#### **Addendum 15 – UN Regulation No. 16**

#### **Revision 8 - Amendment 5**

Supplement 9 to the 06 series of amendments – Date of entry into force: 10 February 2018

#### **Uniform provisions concerning the approval of:**

Figure 7

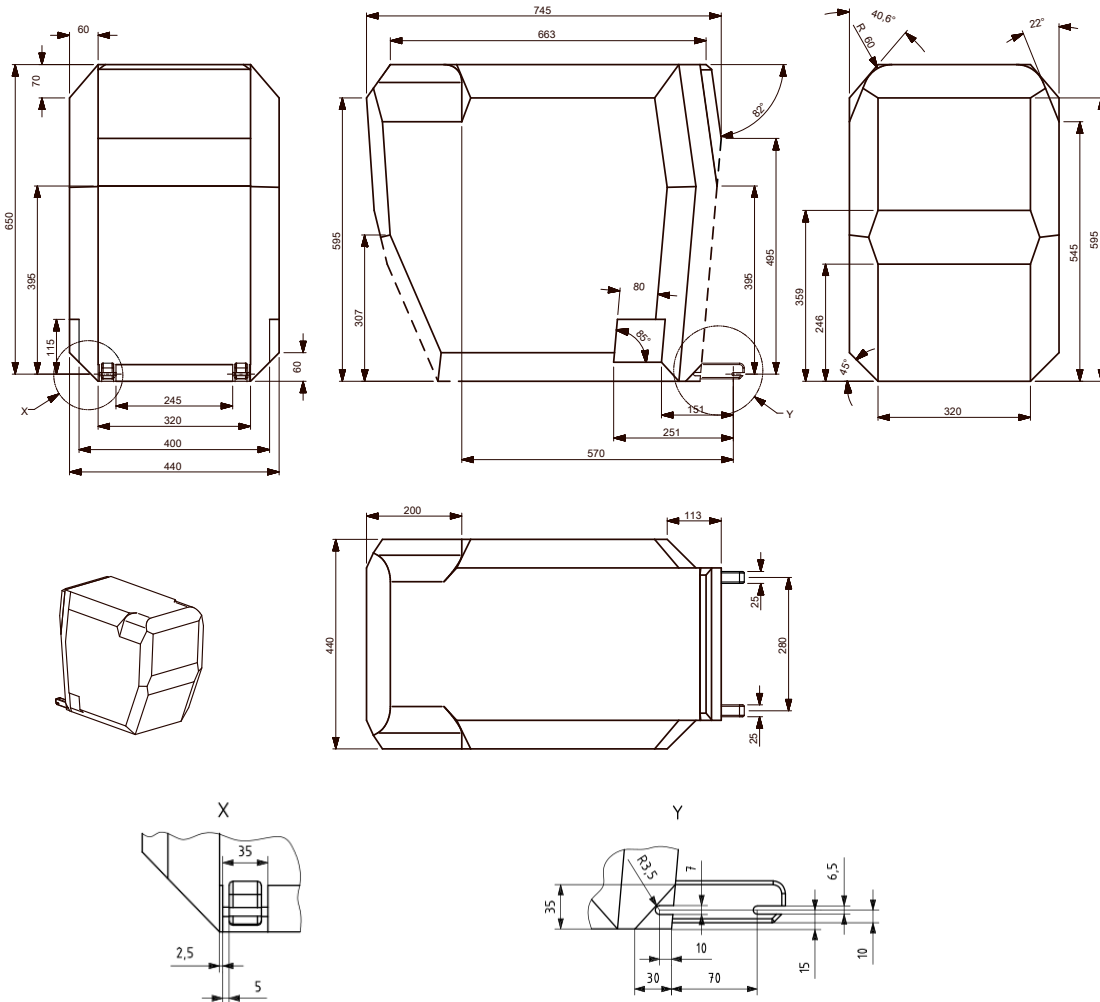
Appendix 2, insert a new paragraph 4.7. and a new Figure 7 to read:

"4.7. Rearward facing infant child restraint systems envelope ISO/R2X

**Reduced-Size Rearward Facing toddler CRS Envelope dimensions for a reduced-size rearward-facing CRS, modified for improved compatibility with the vehicle interior**

Figure 8

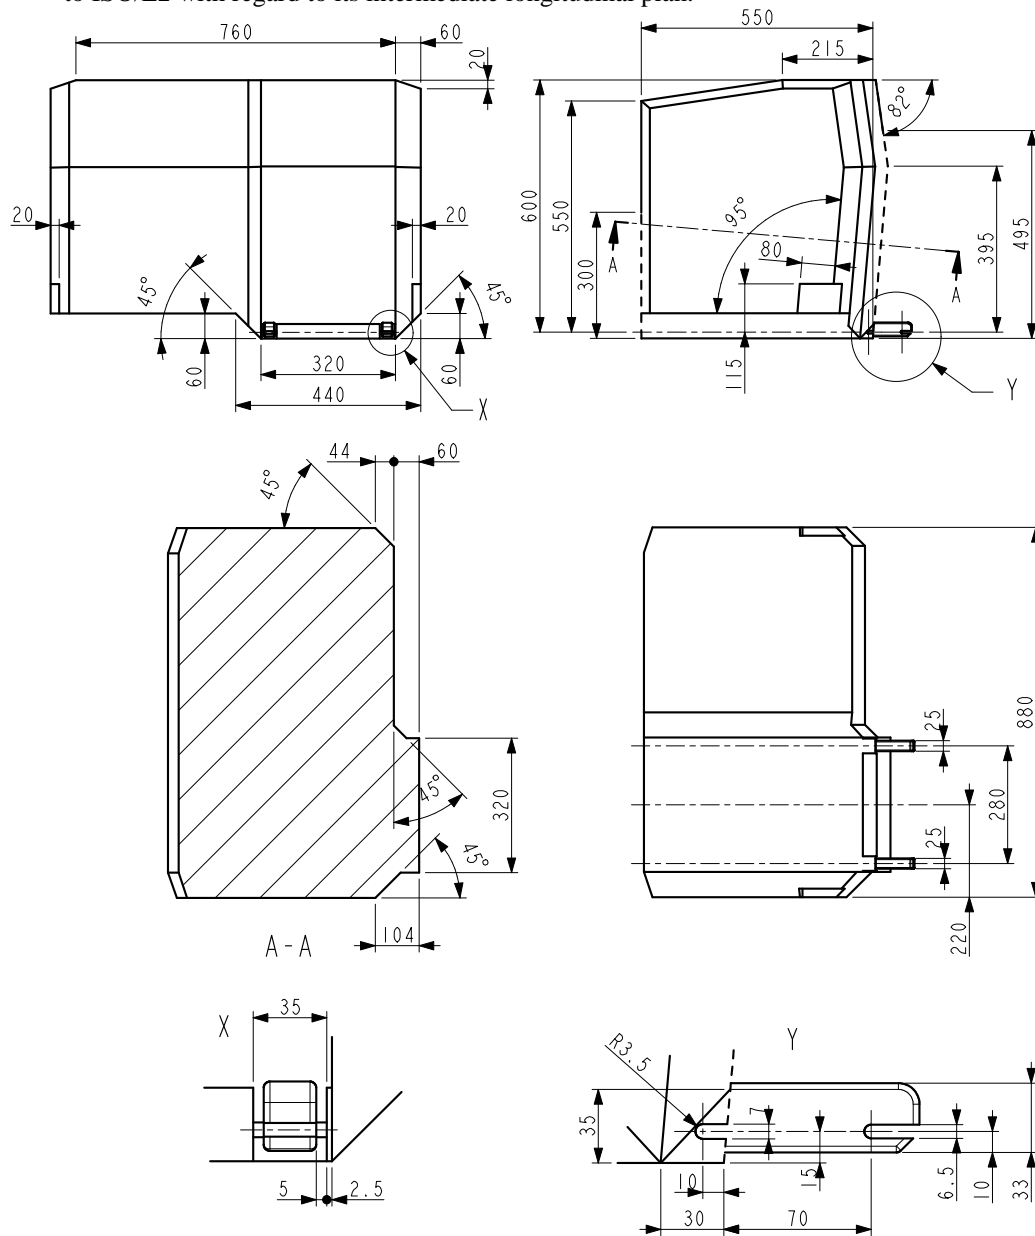
Appendix 2, paragraph 4.7.(former), renumber as paragraph 4.8. and amend to read:

"4.8. Lateral facing child restraint systems envelope

**Envelope dimensions for lateral facing position CRS - ISO/L1- or symmetrically opposite - ISO/L2 (figure shown)**

Note: The envelope for a left lateral-facing infant CRS (ISO/L1) has dimensions symmetric to ISO/L2 with regard to its intermediate longitudinal plan.

Figure 1  
**Positioning in seat**

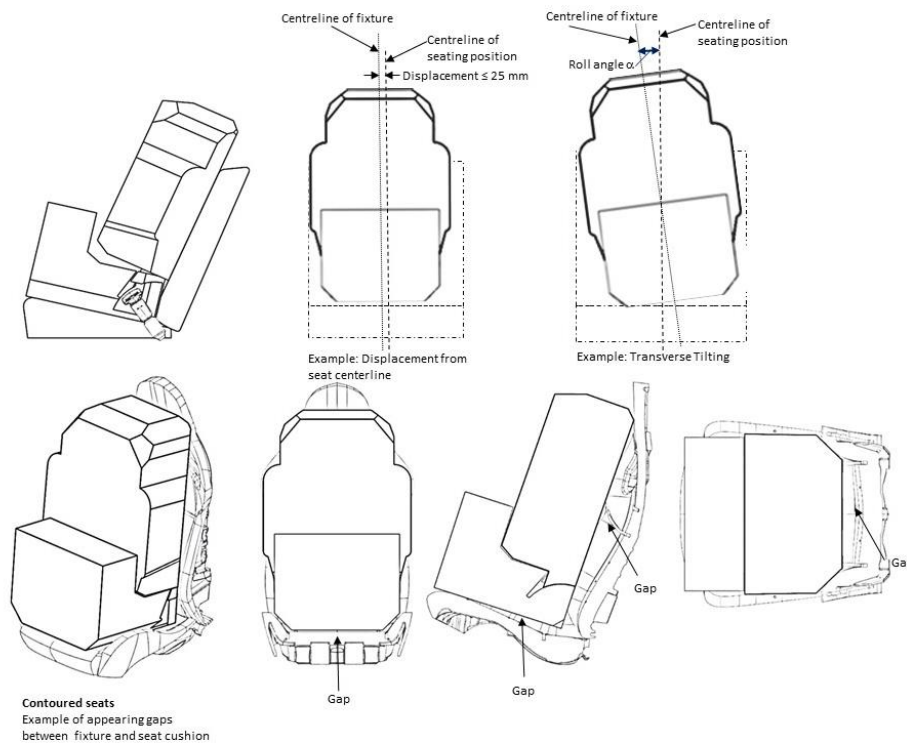
Annex 17, insert a new Appendix 5 to read:

- 2.10. Ensure that the fixture is located with its centreline on the apparent centreline of the seating position  $\pm 25$  mm with its centreline parallel with the centreline of the vehicle seat. The roll angle  $\alpha$  (see figure 1) shall be within  $0^\circ \pm 5^\circ$

3. Requirements
  - 3.1. It shall be possible to secure the fixture in the seating position using the 3-point seat belt and to buckle up the seat belt.
  - 3.2. The roll angle  $\alpha$  as shown in Figure 1 shall be equal to or less than  $5^\circ$ .

- 3.3. The base of the fixture shall be in contact with the seat cushion, and the back face of the fixture shall be in contact with the seat back or head restraint. Full contact with the seat is not necessary, "gaps" due to the vehicle seats contours are permitted as shown by the arrows in Figure 1. The booster seat envelope is equipped with an adjustable backrest. Compatibility with the vehicle seating position shall be achieved in at least one position of the backrest range shown in Figure 2 or Figure 3.
